September 9, 2020
7:00 PM
Planning Board Agenda

Re: Application for Special Use Permit, Subdivision (Lot Line Change) & Site Plan Approvals
Supplemental SEQR Submission
Premises: 416-420 Main Street, Beacon, New York
Tax Parcel IDs: (6054-29-056780 & 6054-29-056774)

Re: 416-420 Main STreet, Beacon, New York
Site Plan Application – Responses to Comments

Re: 416-420 Main Street Subdivision, Site Plan and Special Use Permit
416-420 Main Street
Tax parcels: 6054-29-056780, ±0.18 ac. (416 Main Street)
6054-29-056774, ±0.07 ac. (418-420 Main Street)
City of Beacon, NY

SHEET NUMBER: 3 of 3

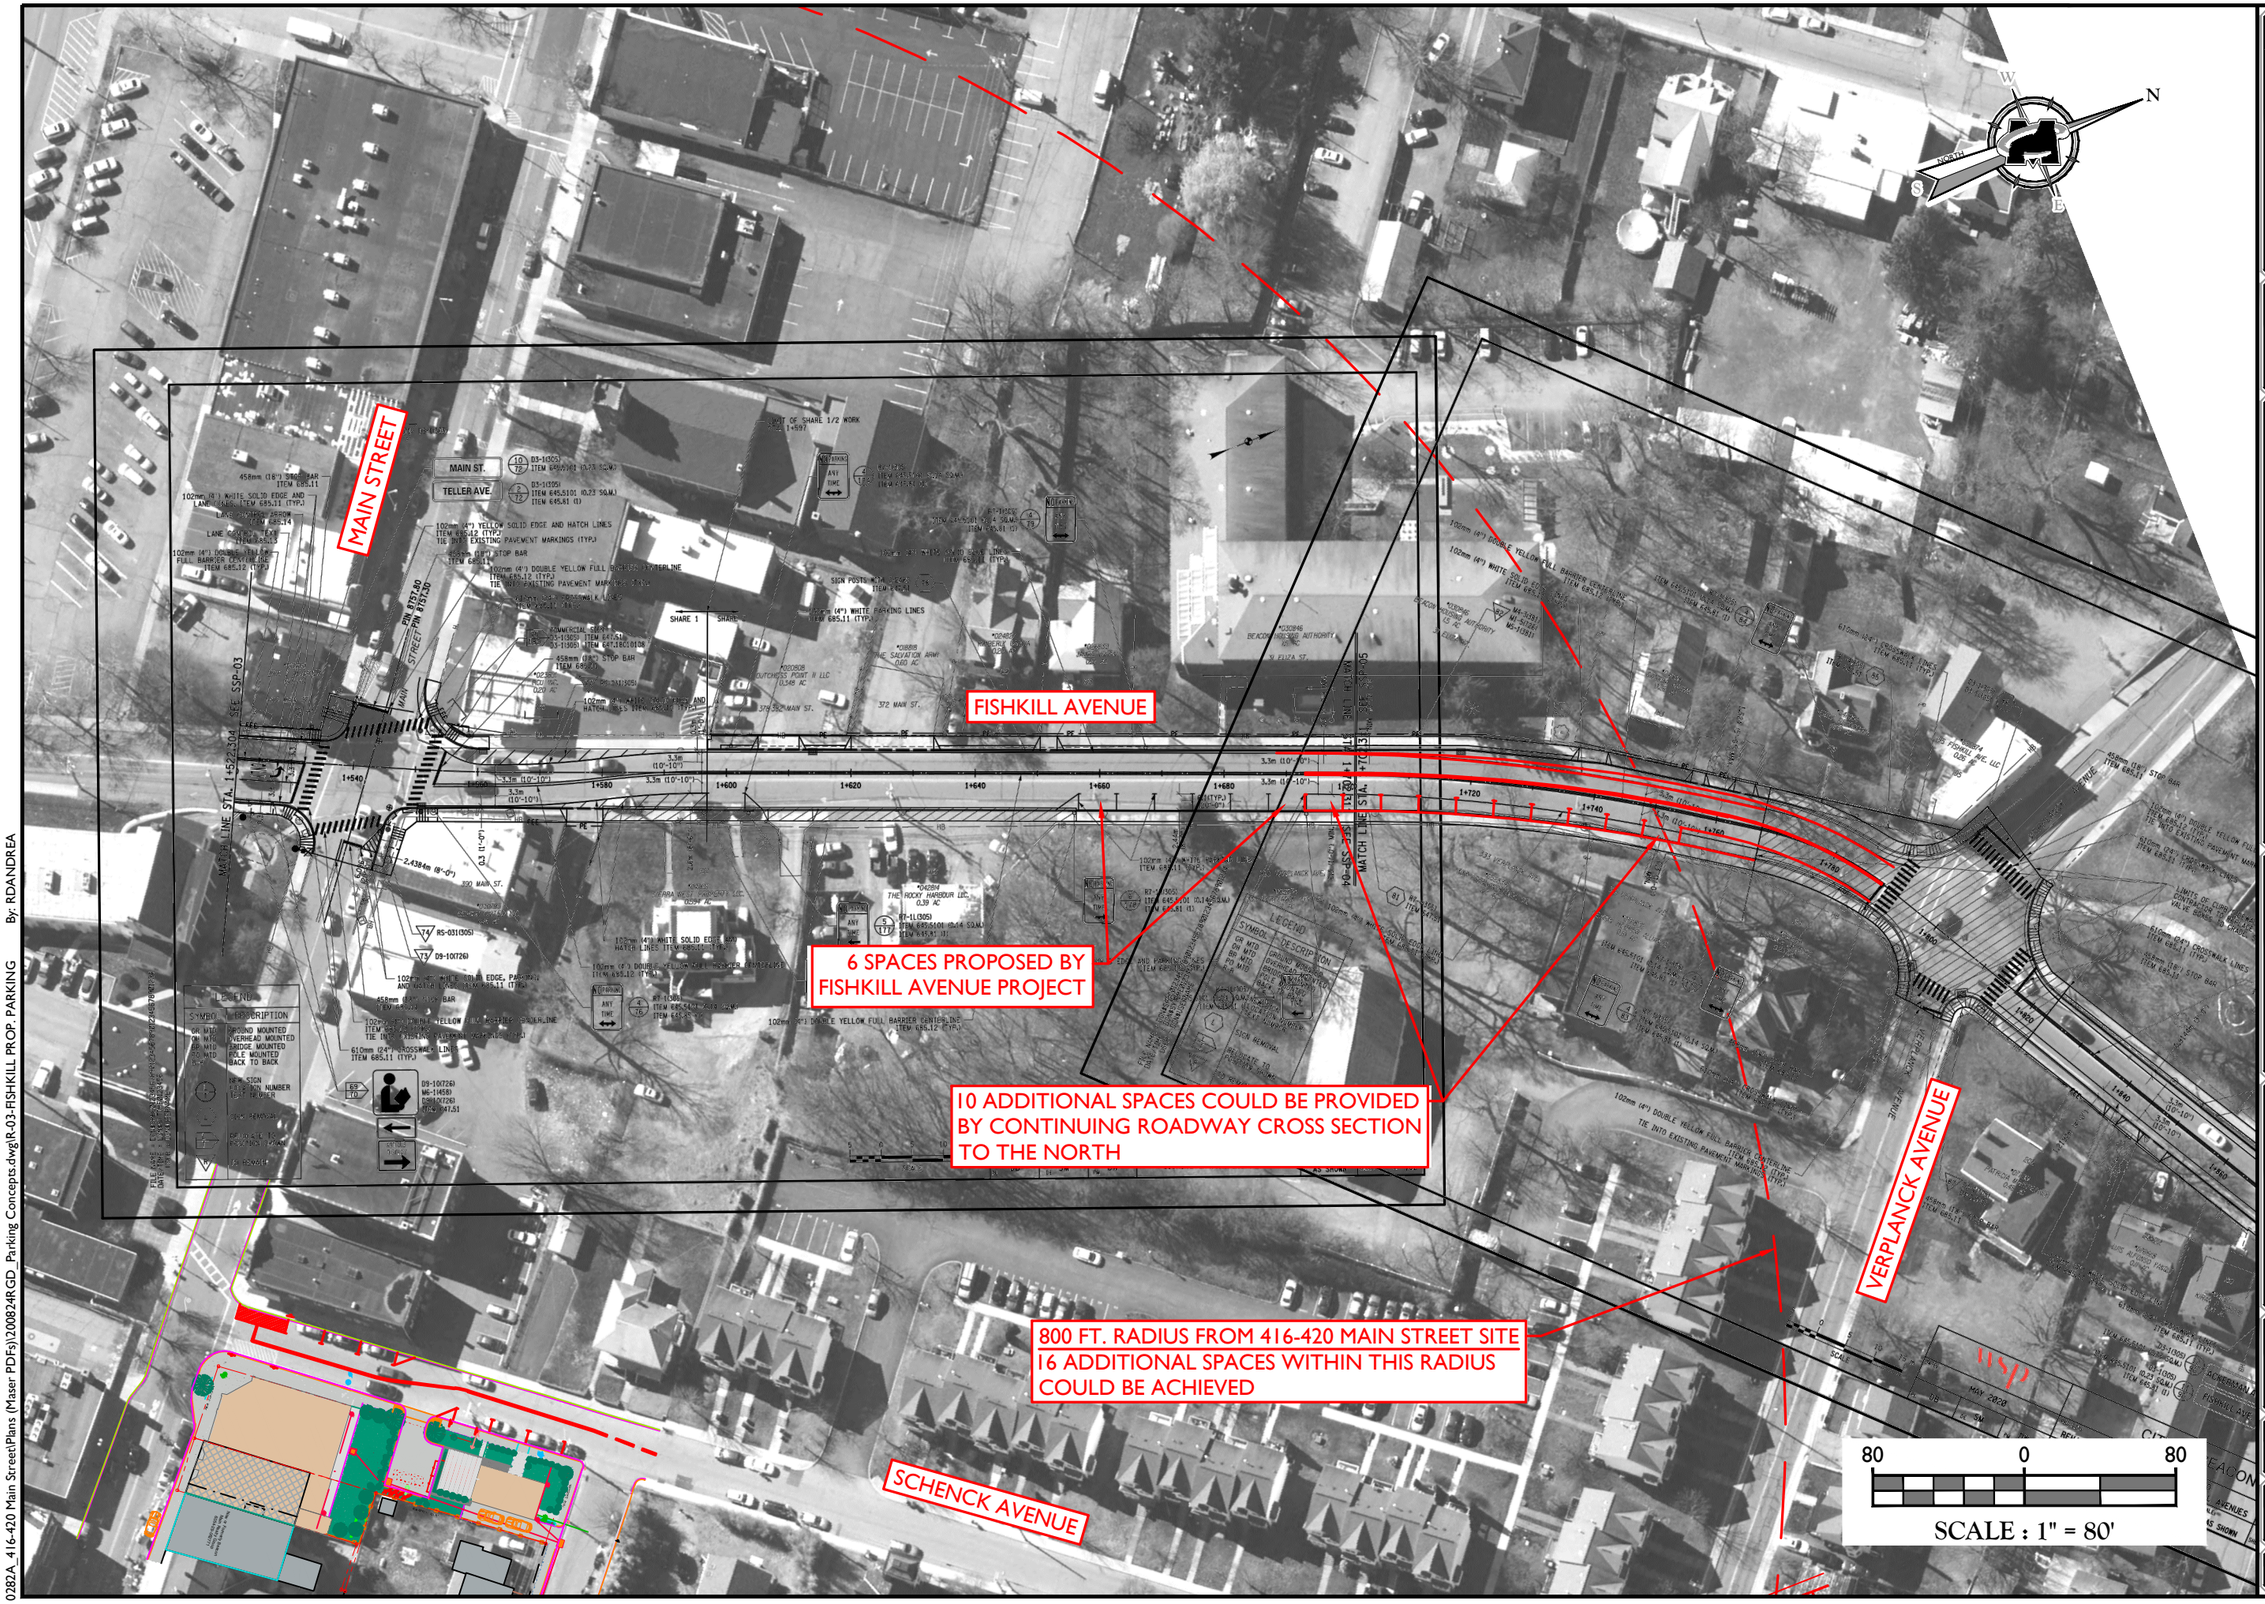
5. Sheet 3 of 3 illustrates the potential additional on-street parking, 16 spaces, that could be gained on Fishkill Avenue within 800 feet of the subject site. Six (6) of these spaces are already proposed as part of the Fishkill Avenue project. The other ten spaces require coordination with WSP Global, the engineering firm currently developing the plans for Fishkill Avenue. Maser indicated that WSP Global and the City will discuss whether this additional parking can be achieved as part of the project. CM finds this approach acceptable.

Response: Comment noted. No further response required.

Sheet 1 of 10 - Site Plan

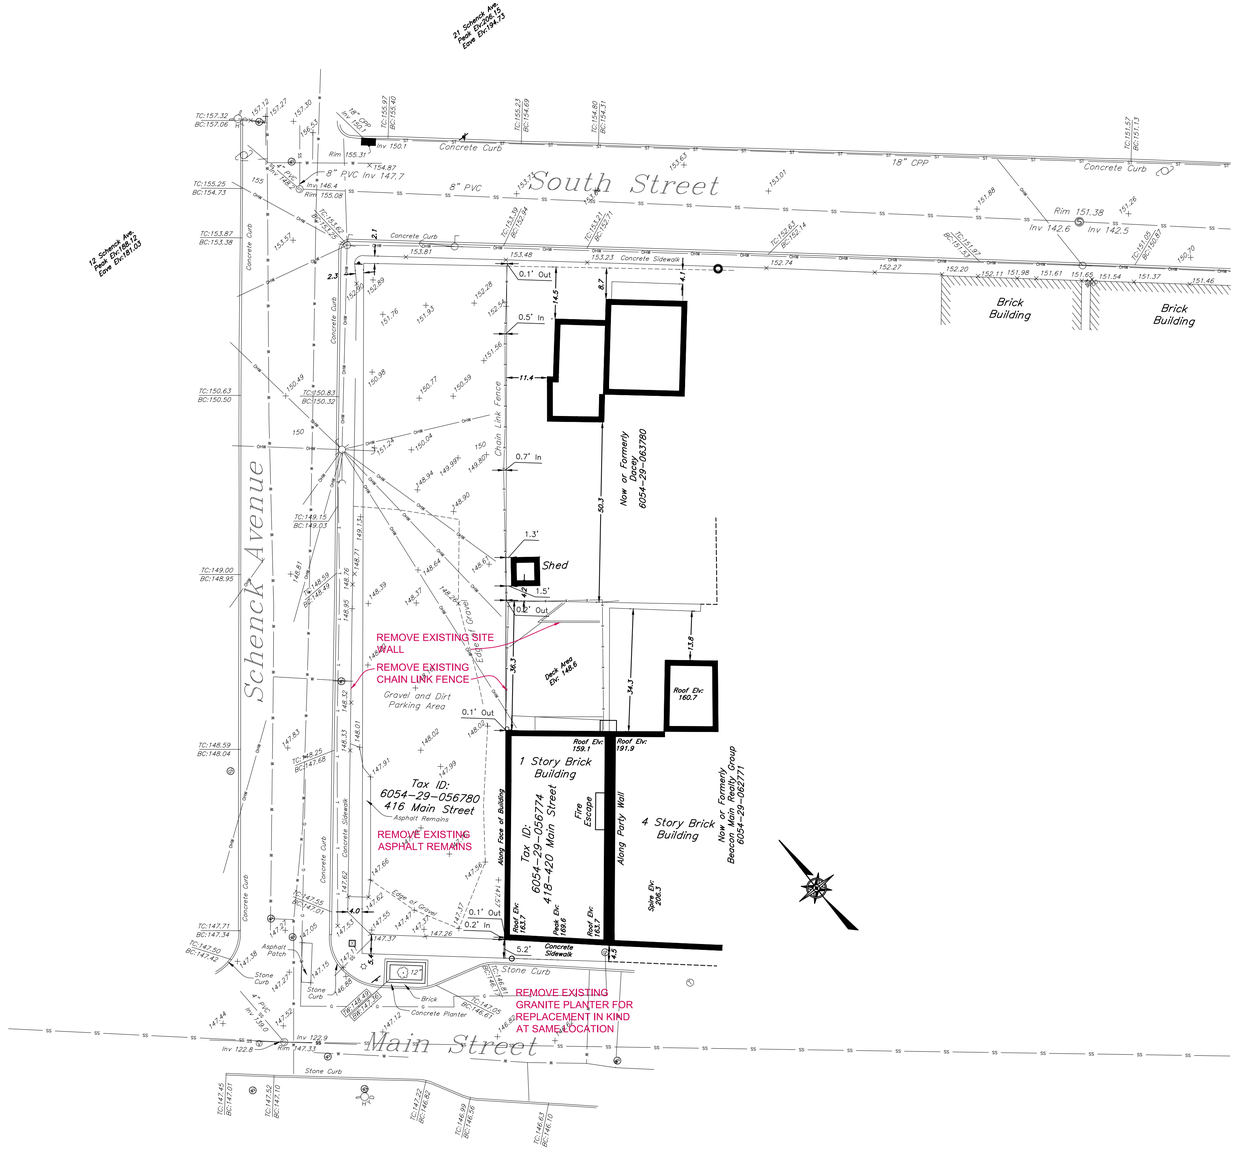
1. For Sheet 1 – Site Plan:
    a The front setback is 9.25' and is aligned with the average building setback within 250 feet of on the south side of South Street, instead of the normally required 10' setback.
    b The duplicate parking table has been removed from the drawing
    c Please refer to the letter from the Landscape Designer, Landscape Restorations, regardingthe existing tree in the planter at the corner of Main Street and Schenck Avenue.
    d Parking below the deck is shown dashed on the site plan

Sheet 4 of 10 - Building Plans

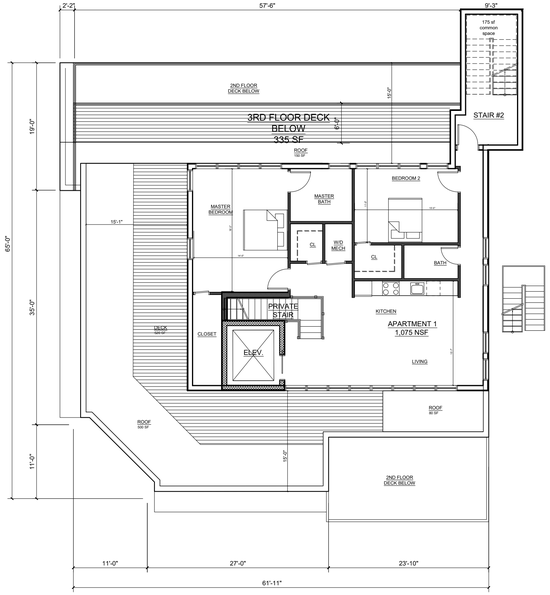
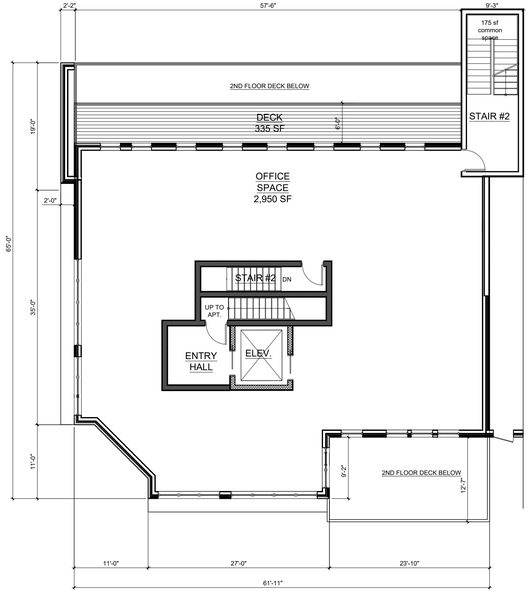
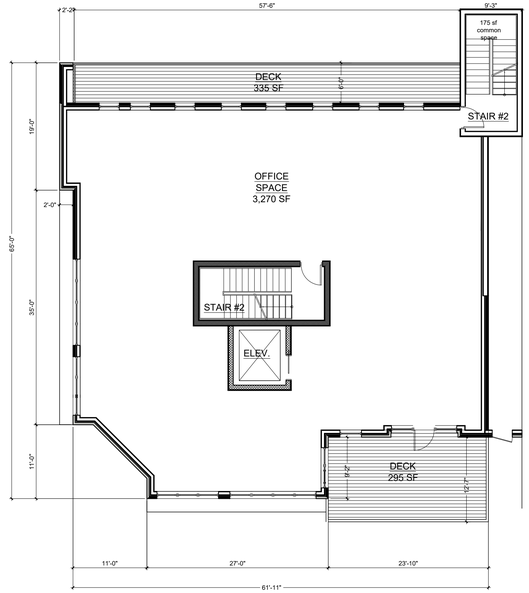
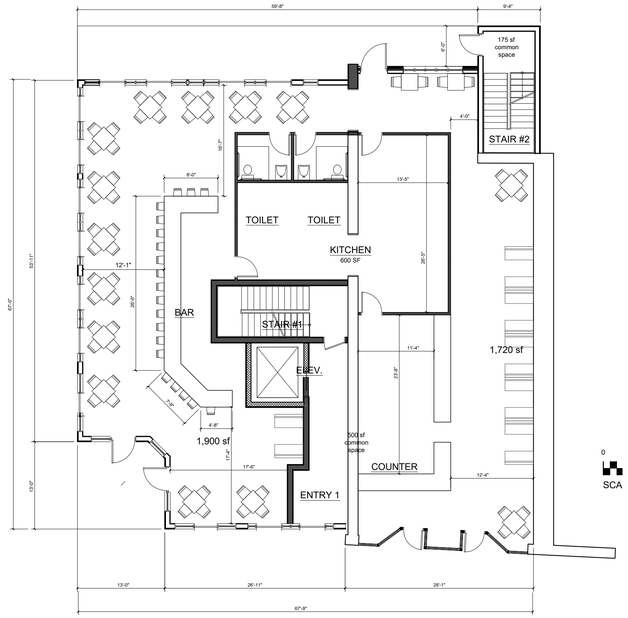
3. For Sheet 4 and 5 – Building Plans
    a Comment acknowledged.
    b Window elevations will be coordinated with building plans
    c Elevations for the live work building will be provided
